PLANNING REPORT

Architectural Review Board

85 Franklin Street 25-071MPR

Location	85 Franklin Street
Proposal	Request for review and approval of construction of new front porch addition and separate rear shed structure for a residence on a .38-acre site.
Request	Review and approval for Minor Project Review (MPR) under the provisions of Zoning Code Section 153.176.
Zoning	HD-HR, Historic Residential District
Planning Recommendations	<u>Disapproval</u> of porch addition <u>Approval</u> of shed
Next Steps	Upon approval of the Minor Project Review, the applicant may apply for building permits through Building Standards.
Applicant	Heidi Bolyard, Simplified Living
Case Manager	Sarah Tresouthick Holt, AICP, ASLA, Senior Planner (614) 410-4662 sholt@dublin.oh.us

Site Location Map

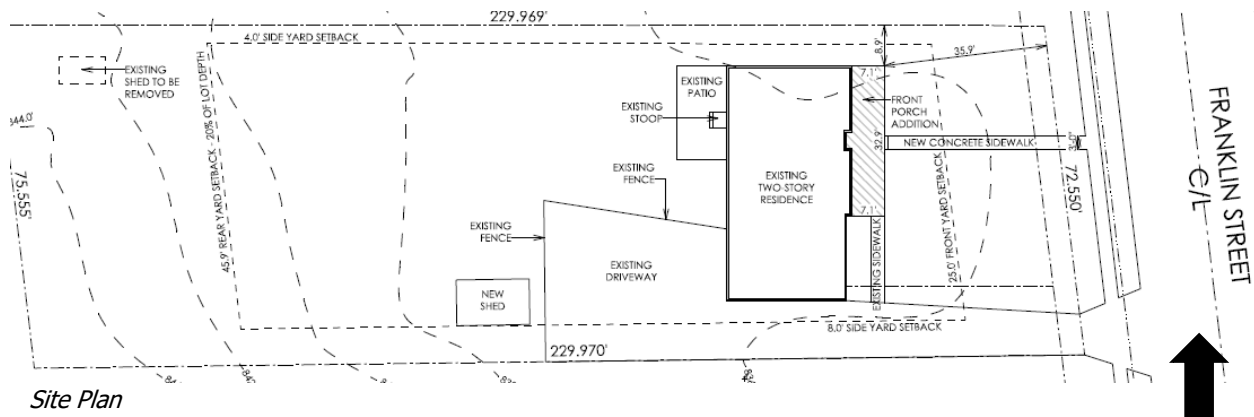
- 1 Houses are consistently set back +/- 60 feet from Street (orange line)

During formal review, staff confirmed the consistent building placement on Franklin Street at +/- 60’ on the west side. While this distance supersedes the architectural details aspect of the

Front porch as proposed, reads as an addition applied to the majority of the front façade

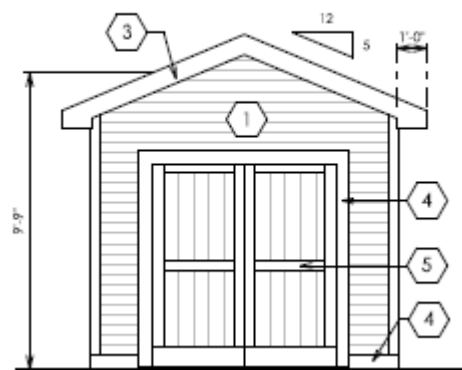
In this resubmittal, the applicant shows a porch inset approximately 18" from the main body of the house on each side. Staff notes the following:

- Code 153.171(B)(3) states that Historic Residential development should maintain and promote the traditional residential character of the District.
- Code 153.173(A) states that development standards are to "preserve the historic character of the area, emphasizing traditional development patterns...."
- Code 153.173(E)(2)(b and c) state that building additions are to be subordinate to primary structures and clearly separated from the original structure in design.
- Guidelines Section 4.12B newly allows Background building additions to the rear *or side*, but not the front.
- Further, Guidelines 2.6, Neighborhood Character and 3.4, Application of the Guidelines, Sections 5.0 and 6.0 state that additions within Historic Residential are encouraged to have consistent setbacks as surrounding structures.
- Based on the above, the front porch addition as shown cannot be supported.

- Entablature details are needed for review.
- Columns should have classical details (i.e. *Get Your House Right, Cusato and Pentreath, page 174*).
- Metal roofing does not exist on the house, so its use on the porch might be reconsidered.
- The indicated front door appears to be a Craftsman style and could be reconsidered for a more appropriate style for the AA.

Other items of concern are listed here in case the applicant wishes to consider a new application:
